AUI Architecture and ILT signaling

Addressing Draft 1.1 comment 516, 508, 357, 478,
224, 225

Matt Brown, Alphawave Semi
Adee Ran, Cisco
Leon Bruckman, Nvidia

176E.3 Functional specification

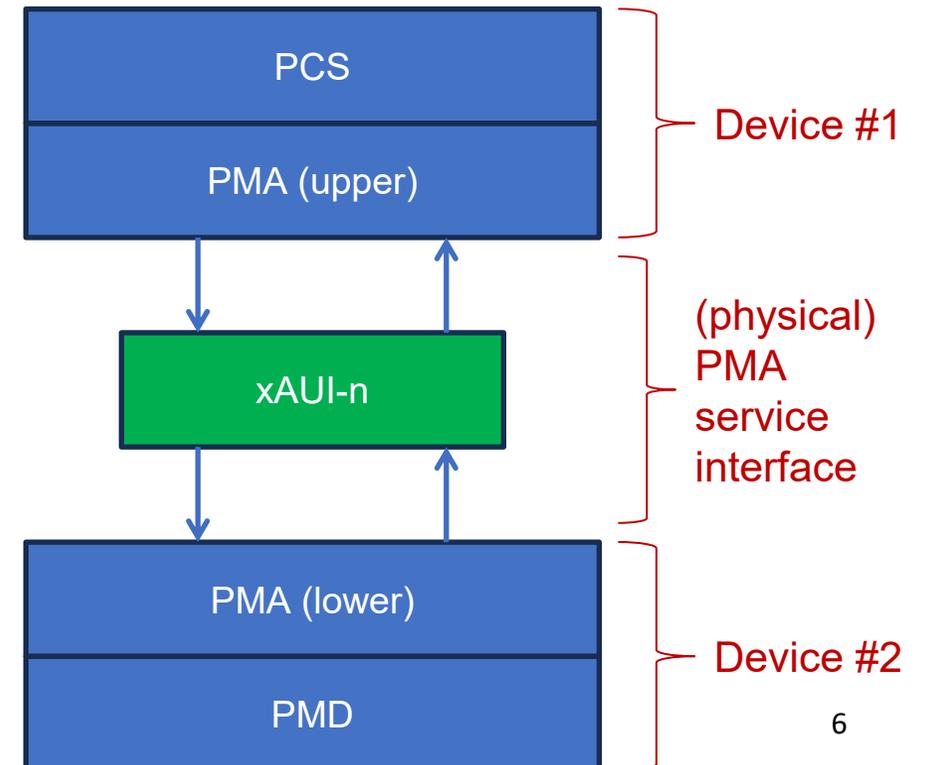
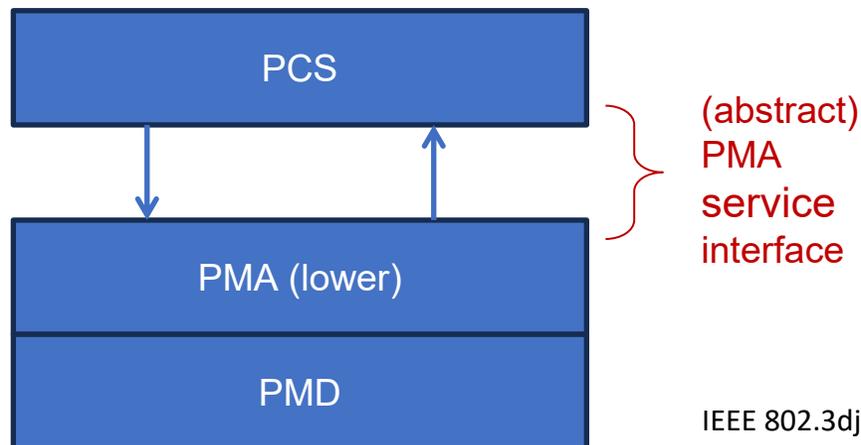
Cl 176E	SC 176E.3	P 695	L 16	# 516
Brown, Matt		Alphawave Semi		
Comment Type	T	Comment Status	X	
The AUI-C2M component is defined as being "functionally equivalent to a corresponding n -lane PMD specified in Clause 179" and includes the same ILT. However, for the AUI-C2M the functional architecture, like the PMD, including the channel, the component at each end, and the abstract service interface signaling are never defined.				
<i>Suggested Remedy</i>				
Define a complete architecture schema for the AUI-C2M as follows: PMA service interface (above the AUI) AUI Component AUI Channel AUI Component PMA service interface (below the AUI) Implement similarly for AUI-C2C in Annex 176D. A presentation with a more complete proposal will be provided.				
Proposed Response	Response Status O

Figure 176D/E-x—Inter-sublayer service interfaces for a 200GAUI-1, 400GAUI-2, 800GAUI-4, 1.6TAUI-4 C2C/C2M

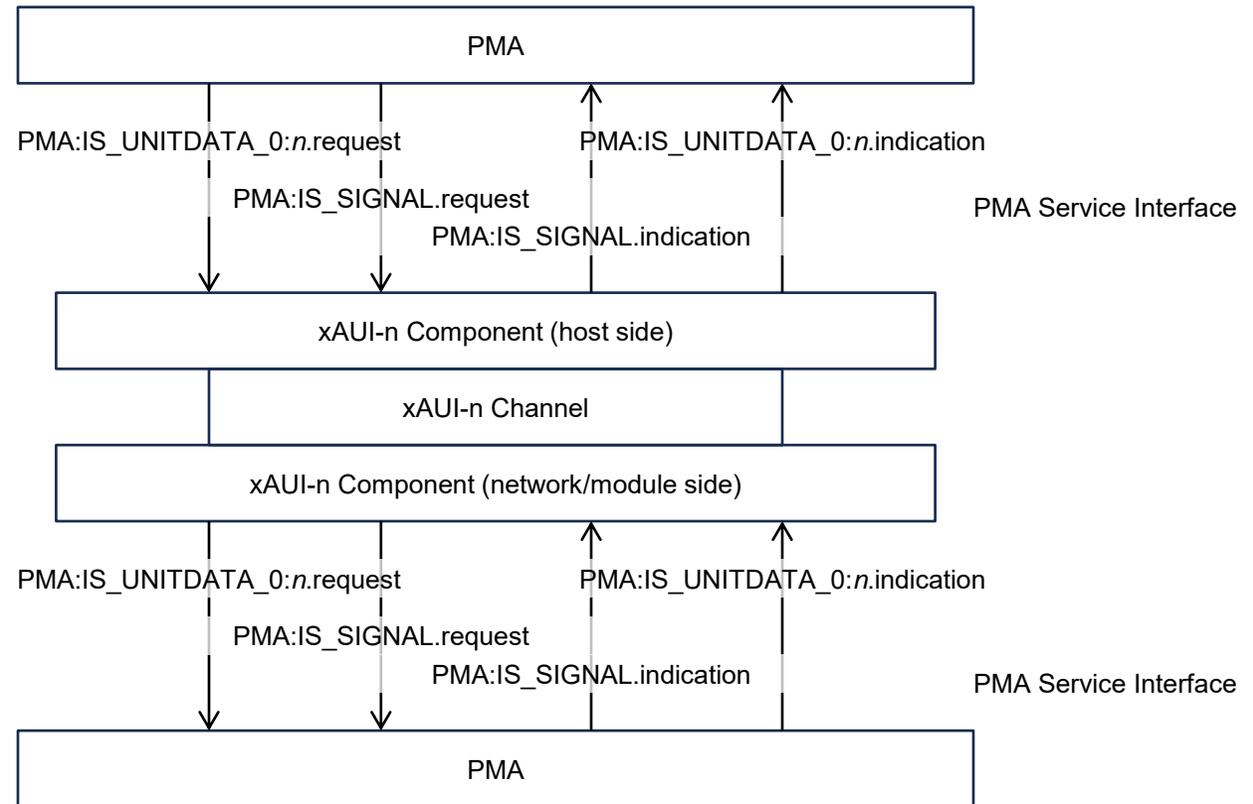
However, as noted earlier, an abstract messaging conduit between the xAUI-n and the PMA above and below is required.

A supporting diagram and text should be provided in each xAUI-n annex.

Add the diagram to the right to Annex 176D and 176E in a new subclause defining the service interfaces.

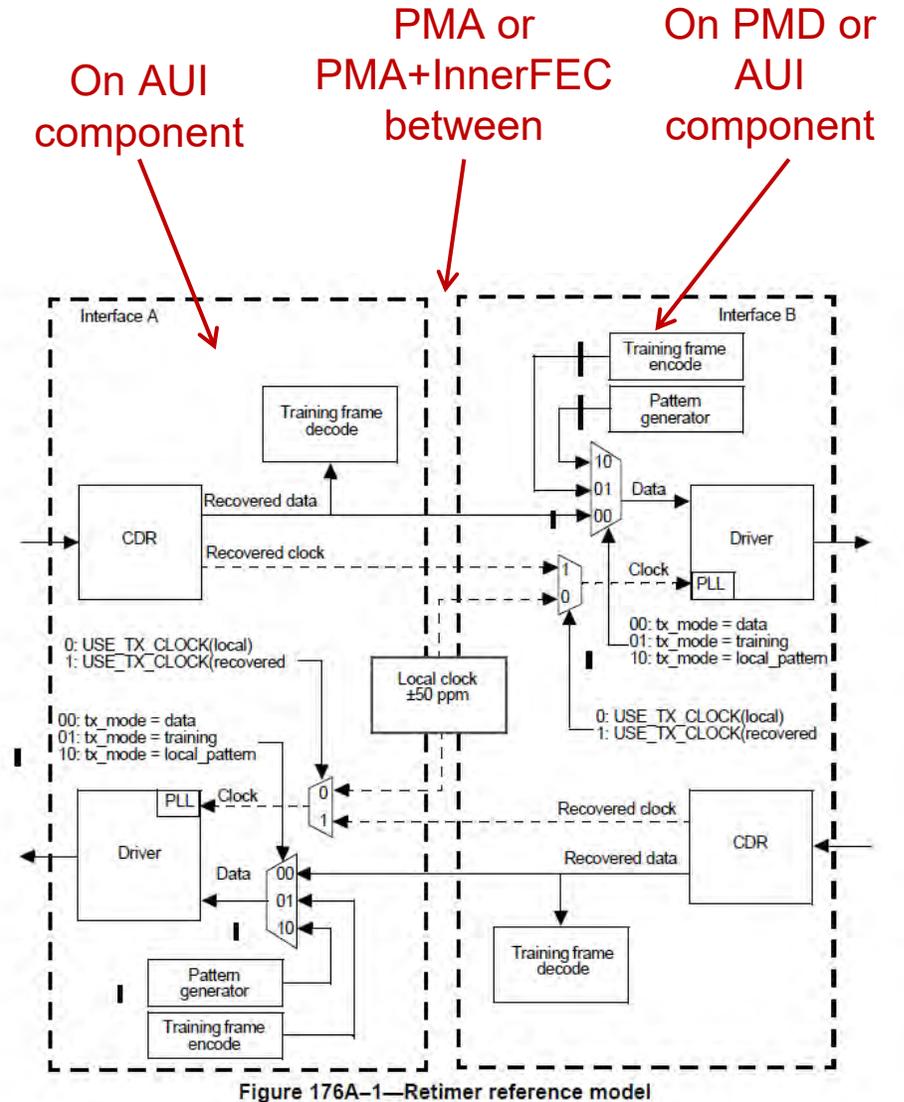
The ILT function includes provision for careful sequencing of clock source and data source.

It is currently depicted as though the two interfaces are within the same sublayer.

However, as shown on the previous slide there is another sublayer between.

Text and/or diagrams are needed to convey this.

Figure 176A-6—RTS update state diagram

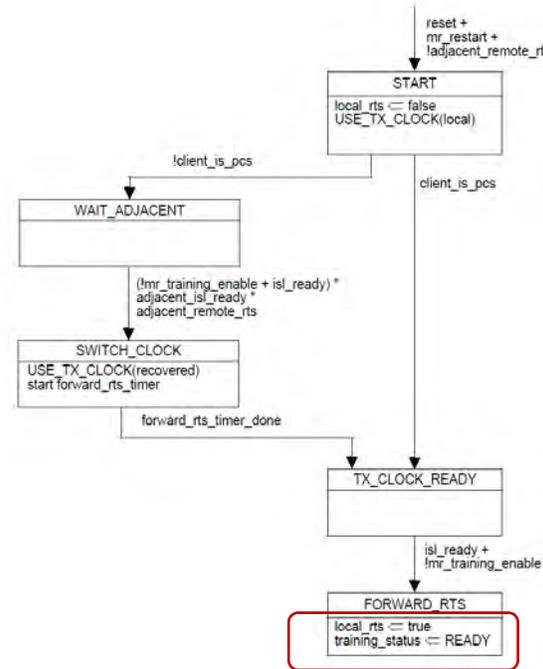
The editor's note points out that the location of the Figure 176A-6 state diagram needs to be specified. Given that there is one per interface and since the ILT function is part of the PMD or AUI component the location is implicit.

Editor's note: Need to define where is the RTS state diagram implemented, or leave it open for the implementor's decision

Delete the editor's note.

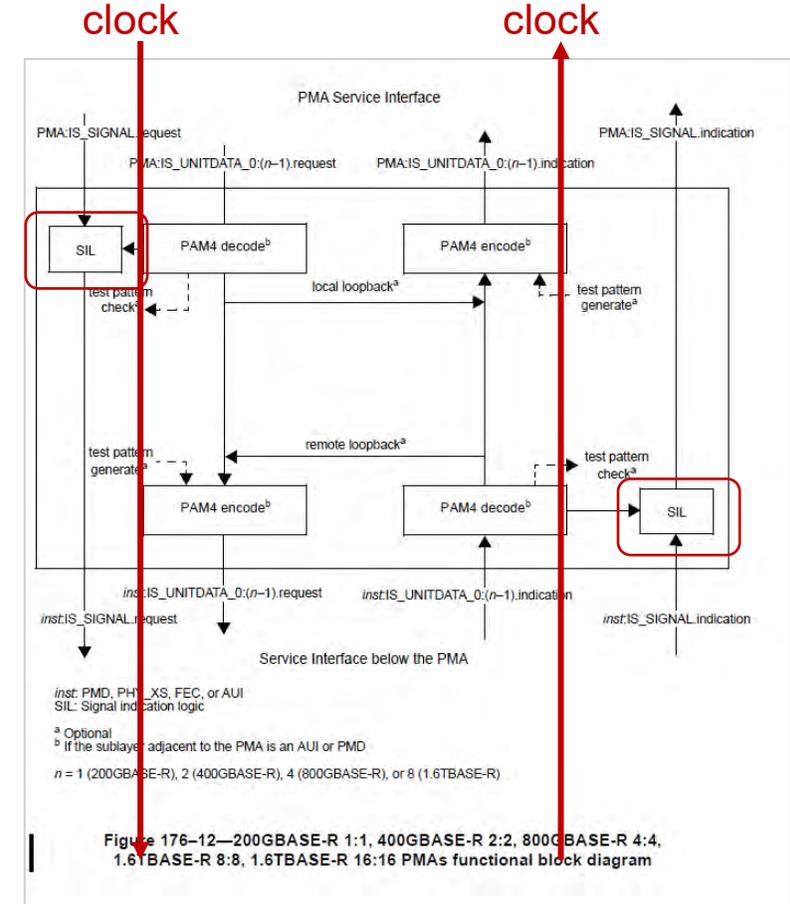
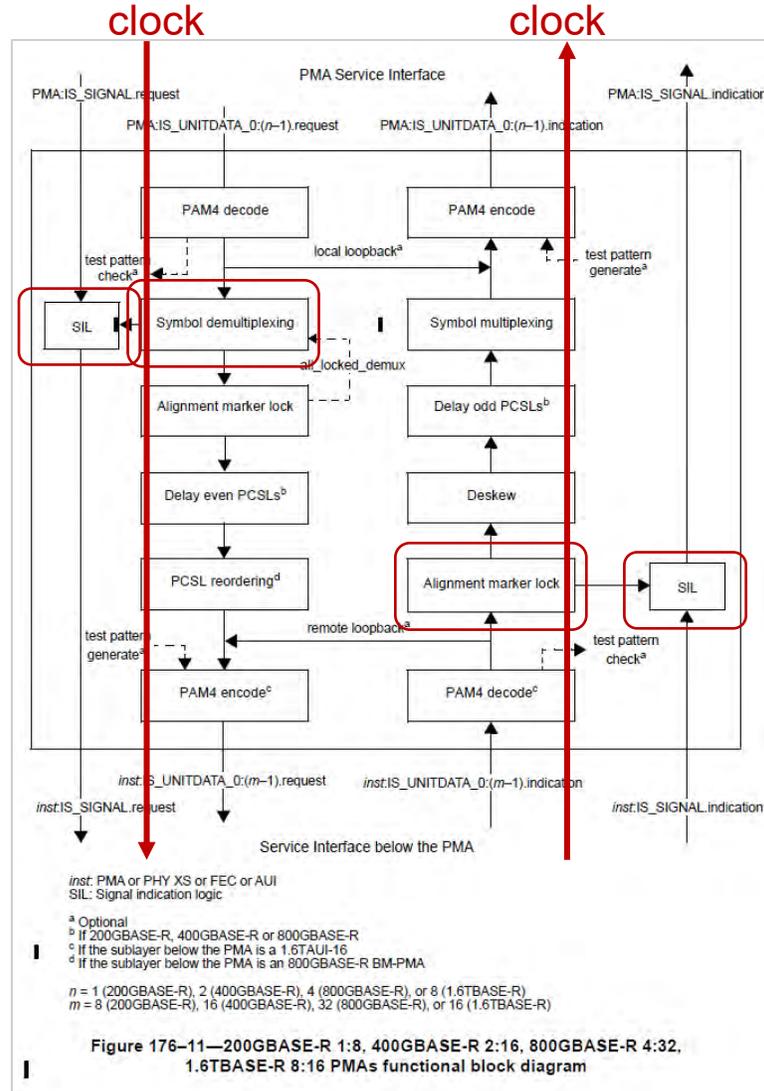
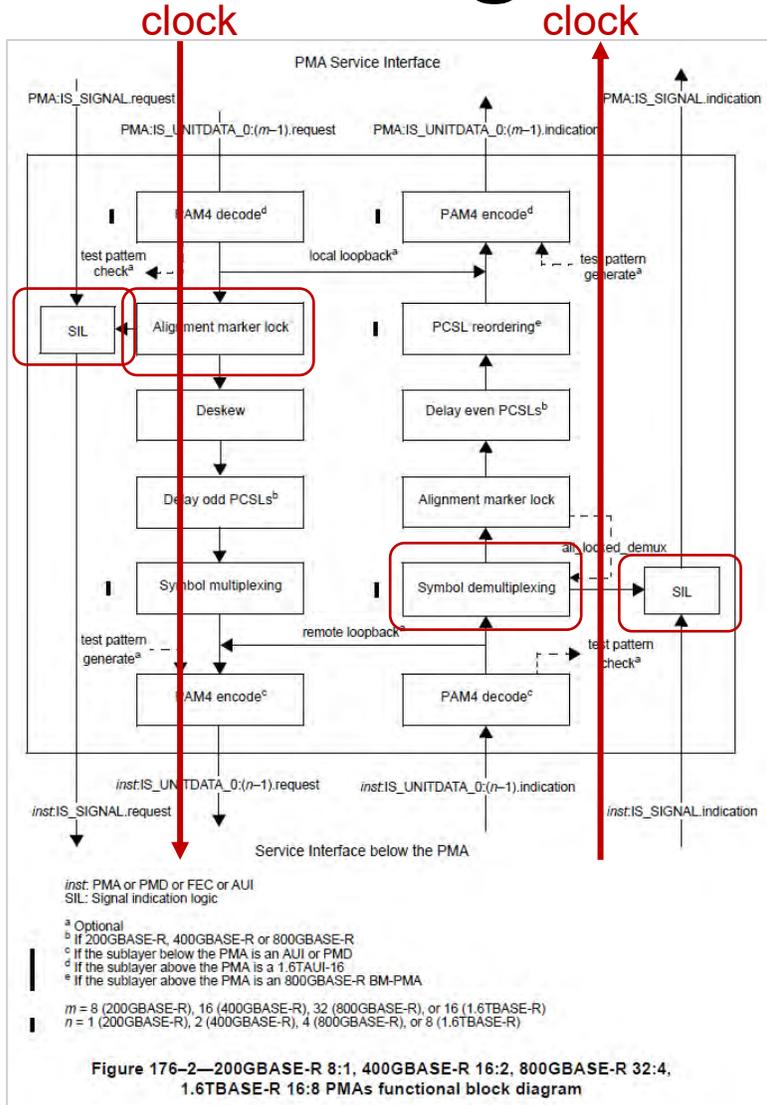
The variables `adjacent_remote_rts` and `adjacent_isl_ready` are defined in Draft 1.1 as shown top right.

These are not sufficiently complete.

Change these definitions as shown in the bottom right.

`adjacent_remote_rts`

Boolean variable that indicates the value of `remote_rts` on the other interface of the device. It is set to true if the parameter `SIGNAL_OK` is OK and is otherwise set to false.

`adjacent_isl_ready`

Boolean variable that indicates the value of `isl_ready` on the other interface of the device. It is set to true if the parameter `SIGNAL_OK` is OK or `READY` and is otherwise set to false.

NOTE – `SIGNAL_OK` is received via the `IS_SIGNAL.request` primitive for an AUI component above an AUI channel or a PMD, or via the `IS_SIGNAL.indication` primitive for an AUI component below an AUI channel.
